UNITED STATES PATENT AND TRADEMARK OFFICE

APPLICATION NO.	FILING DATE	FIRST NAMED INVENTOR	ATTORNEY DOCKET NO.	CONFIRMATION NO.
10/757,419	01/15/2004	Berndt Brenner	P24717	3378
7055 7590 01/25/2008 GREENBLUM & BERNSTEIN, P.L.C. 1950 ROLAND CLARKE PLACE RESTON, VA 20191			EXAMINER DINH, TIEN QUANG	
			ART UNIT 3644	PAPER NUMBER
			NOTIFICATION DATE 01/25/2008	DELIVERY MODE ELECTRONIC

Office Action Summary	Application No.	Applicant(s)	
	10/757,419	BRENNER ET AL.	
	Examiner	Art Unit	
	Tien Dinh	3644

DETAILED ACTION

Fig. 1

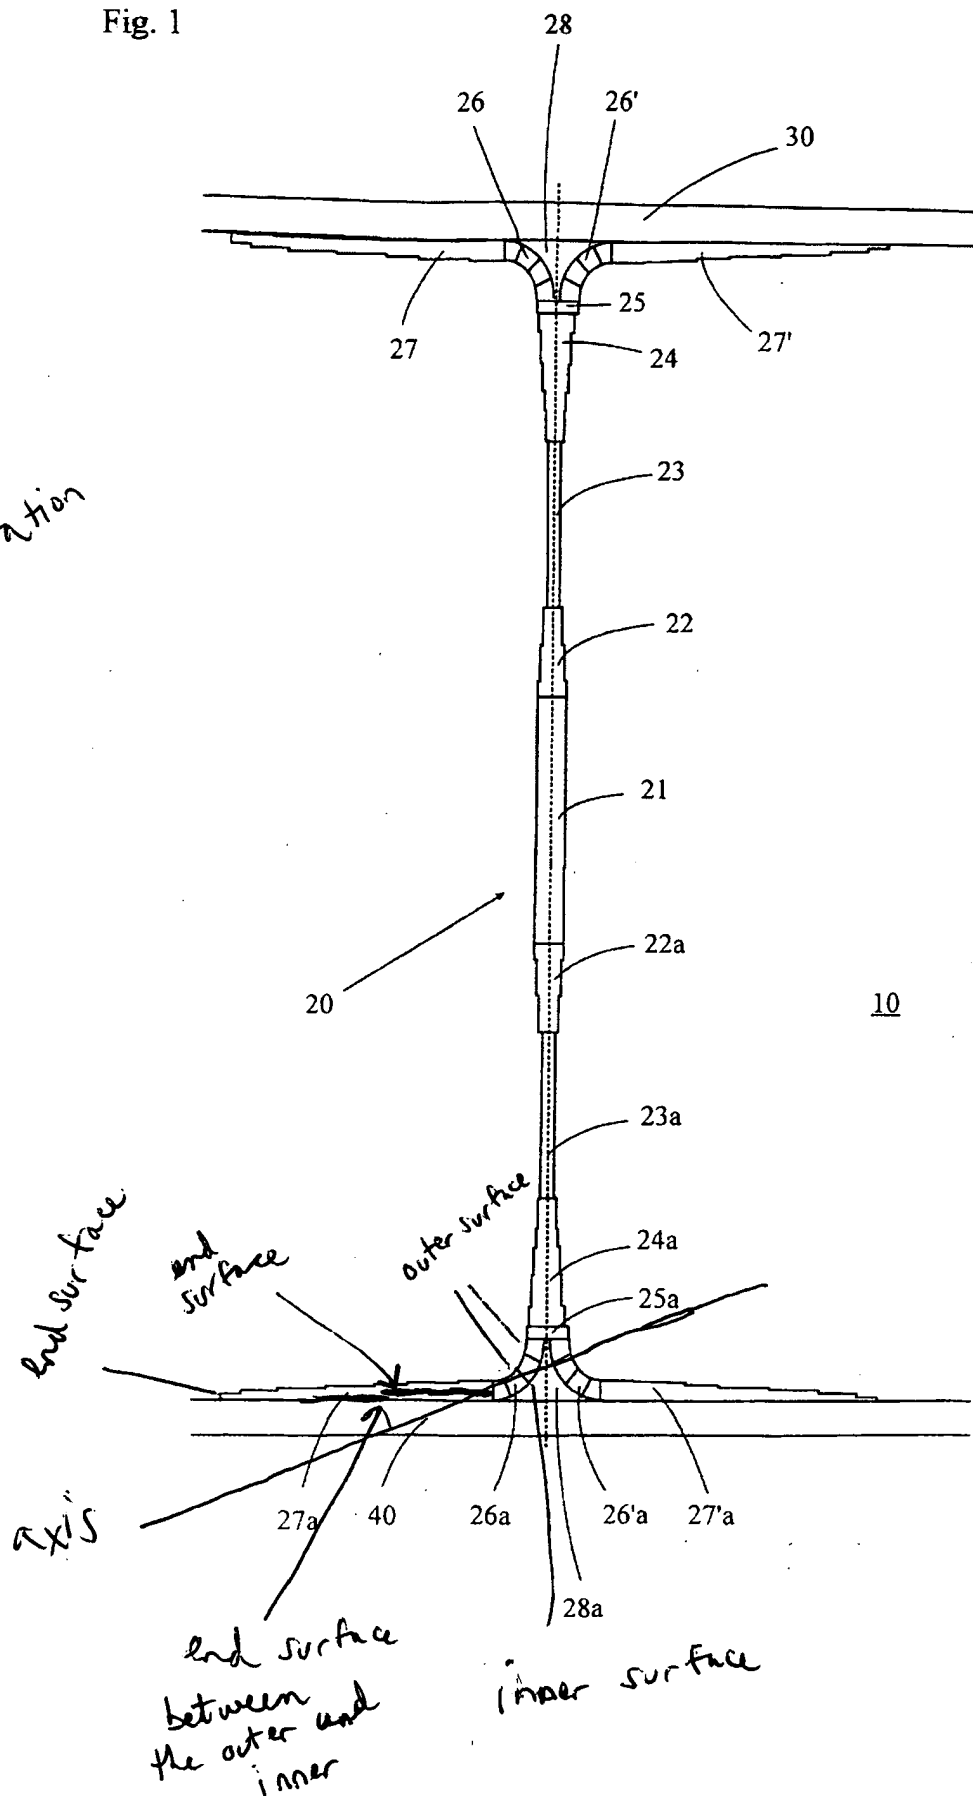
The examiner appreciates the interview also. Upon reviewing the claims and the Mueller reference, the examiner maintains that this reference along with the secondary references still read upon what is claimed. The examiner has attached two marked up drawings of figure 1 to help the applicant understand the interpretation. The first interpretation shows that the end surface is part of element 27a or the surface of element 27a that touches the skin 40, 30. The claims do not call for directly connected to the metal panel. Hence any surface that is part of the element 27a that is between the inner and outer surface meets what is claimed. The part that is between the inner and outer surface (as marked up) can broadly be interpreted as the end surface. The examiner has marked up many interpretation of what the end surfaces are. It could be the end part of element 27a or the part that is marked with a solid line.

In the second interpretation, the end surface is marked up. It is between the inner and outer surface. The end surface is connected to the metal panel in a material-locking manner such as adhesive or welding as taught by Schmidt or Palm. The end surface is connected directly to the skin 40 or it is indirectly connected to the skin. Either way, it shows what is claimed.

Lastly, the examiner has drawn an axis passing through each side piece and through the weld zone. An axis can be drawn through the side piece since the axis can be any line through the side piece and the weld zone. An axis is defined as "line segment serving to orient a space or a geometric object."
